PROJECT
SKETCHLEY LANE BURBAGE

TITLE
EXTERNAL LEVELS SH2 OF 3

PROJECT NO.	DRAWING NO.	REV
23053	111	N

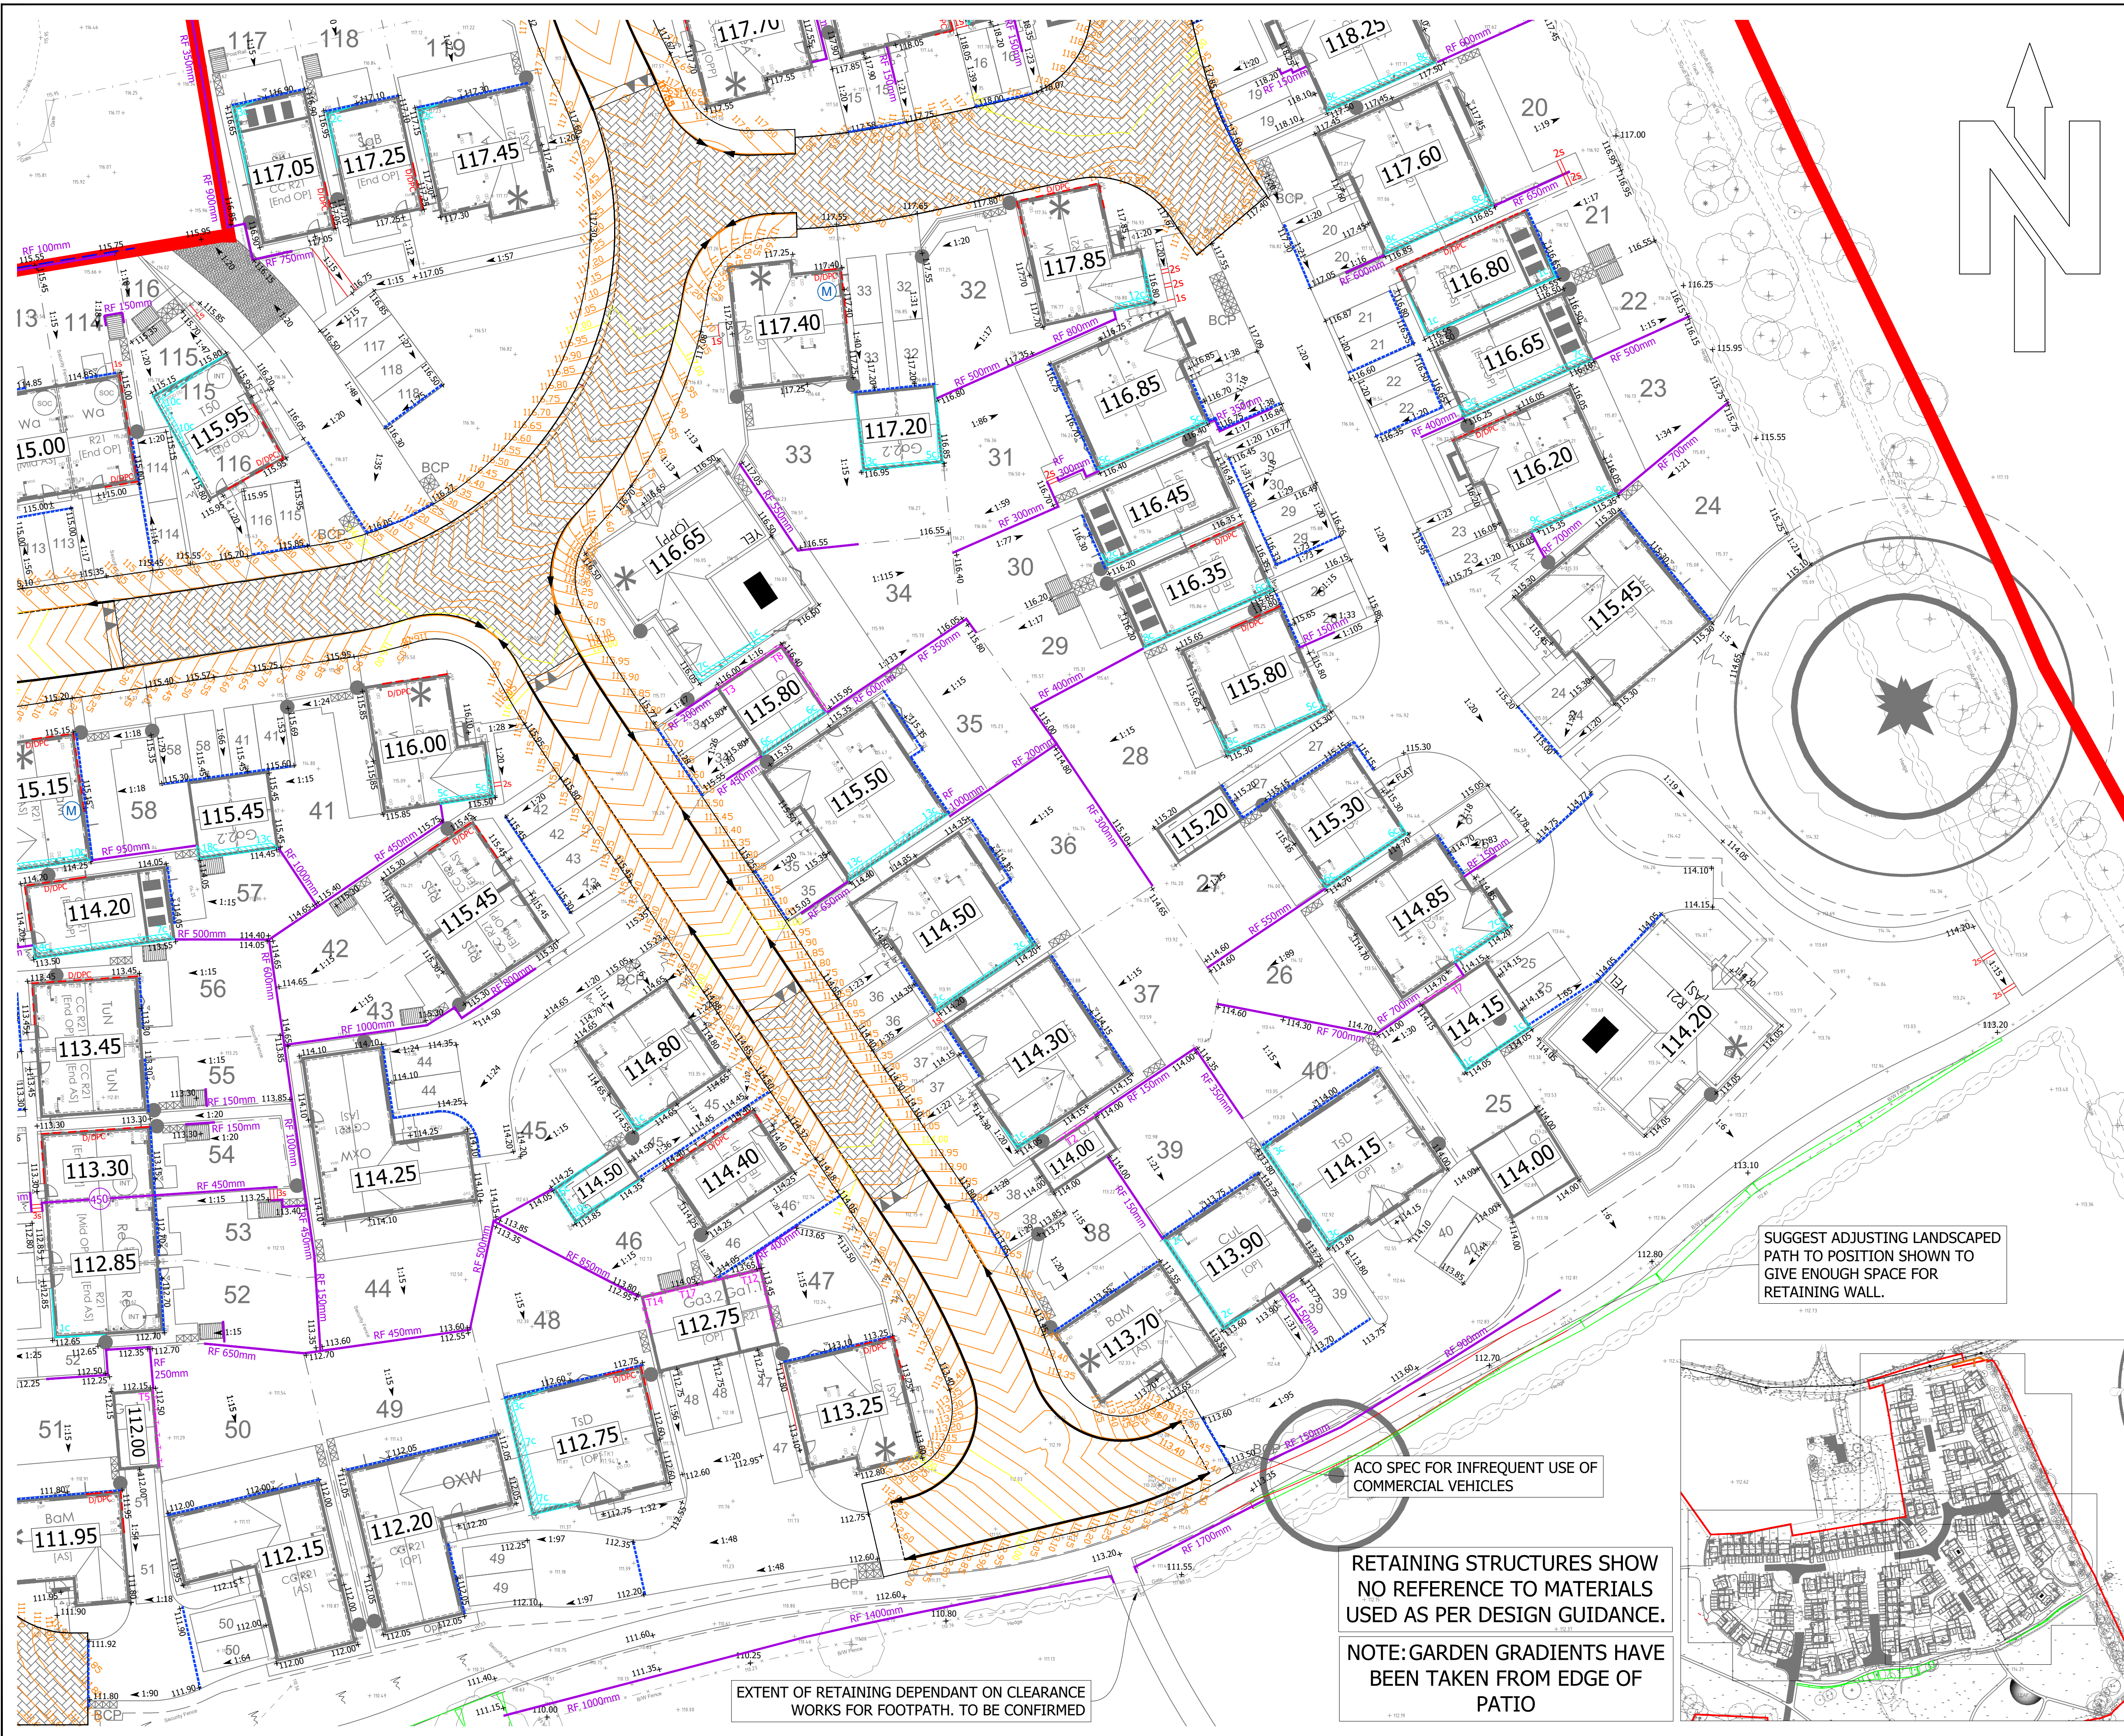
SUGGEST ADJUSTING LANDSCAPED PATH TO POSITION SHOWN TO GIVE ENOUGH SPACE FOR RETAINING WALL.

RETAINING STRUCTURES SHOW NO REFERENCE TO MATERIALS USED AS PER DESIGN GUIDANCE.

EXTENT OF RETAINING DEPENDANT ON CLEARANCE WORKS FOR FOOTPATH. TO BE CONFIRMED
